February 7, 2023

URGENT MEDICAL DEVICE CORRECTION

Datascope Cardiosave Hybrid and Rescue Intra-Aortic Balloon Pumps (IABP)

Figure 2: As pictured in **Cardiosave Hybrid and/or Rescue Operating Instructions**

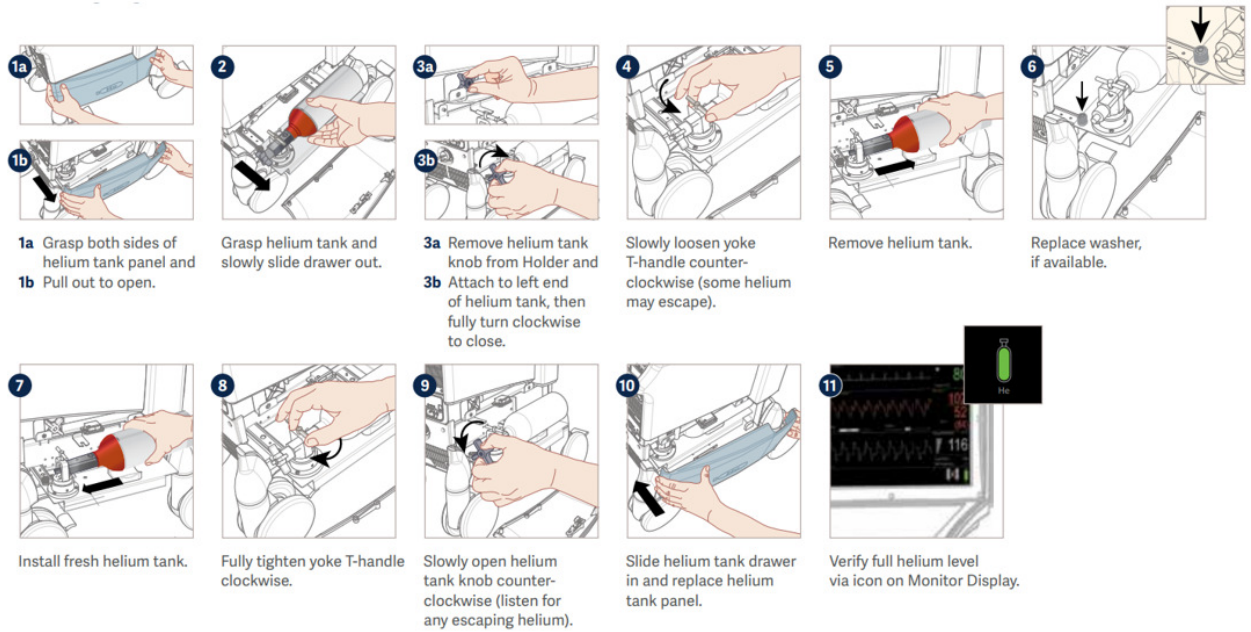
There have been reported failures of the high pressure helium regulator which may cause a helium leak in the Cardiosave Hospital Cart. The high pressure helium regulator is located in the Cardiosave Hospital Cart and regulates the helium pressure of the external helium supply. In instance of helium regulator failure, a Pump Console's internal reservoir of helium will not be replenished when docked into an impacted Hospital Cart. This may result in an insufficient amount of helium within the internal reservoir. Please refer to images below for reference.

3. If user observes any visual damage on High Pressure Regulator, please contact your Datascope/Getinge service representative.

1. During Installation and Replacement of the Helium Tank per the Cardiosave Operating Instructions, please ensure care is taken not to damage the helium tank or the helium tank yoke while inserting and/or removing the helium tank.
2. Please follow the instructions for use when changing the helium tank.

Datascope/Getinge is currently investigating this issue to determine root cause and will notify customers if additional action is to be taken to correct the issue.

Figure 3: Drawings as pictured in **Cardiosave Hybrid and/or Rescue Operating Instructions**, along with a final picture of the O-ring as it appears on the unit.

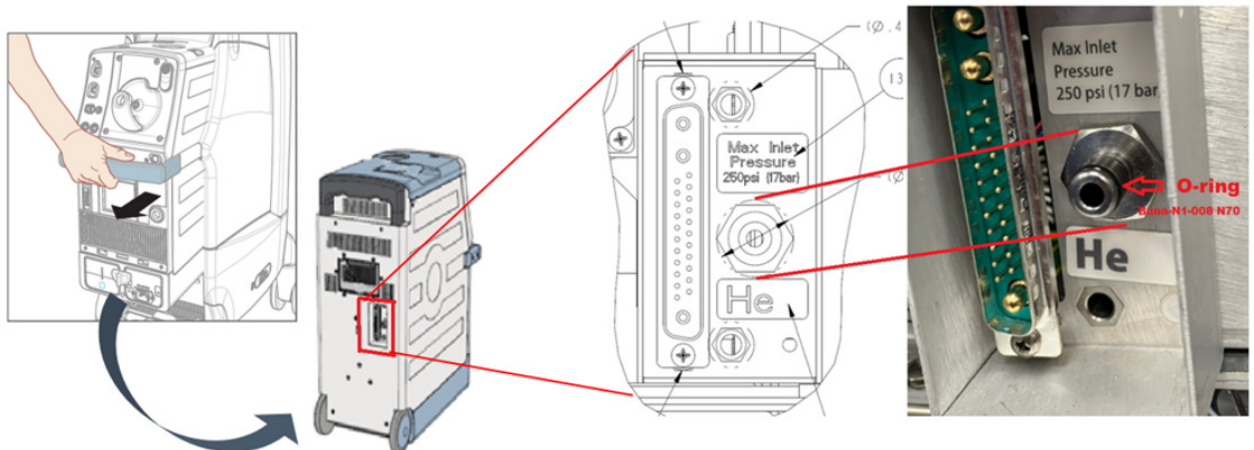
There have been reports of damaged, worn, or torn O-rings on the Cardiosave Pump Console quick disconnect fitting resulting in helium tank leaks. The quick disconnect fitting is the point of connection that permits the refilling of the Pump Console's internal helium reservoir when the Pump Console is docked in the Hospital Cart. Please refer to images below for reference.

1. If user observes any visual damage to the O-ring installed as part of the quick disconnect fitting, please contact your Datascope/Getinge service representative. If possible, remove the IABP from patient use until appropriate repairs can be made.

Datascope/Getinge is currently updating the annual Preventive Maintenance instruction to include replacement of the quick disconnect fitting O-ring.
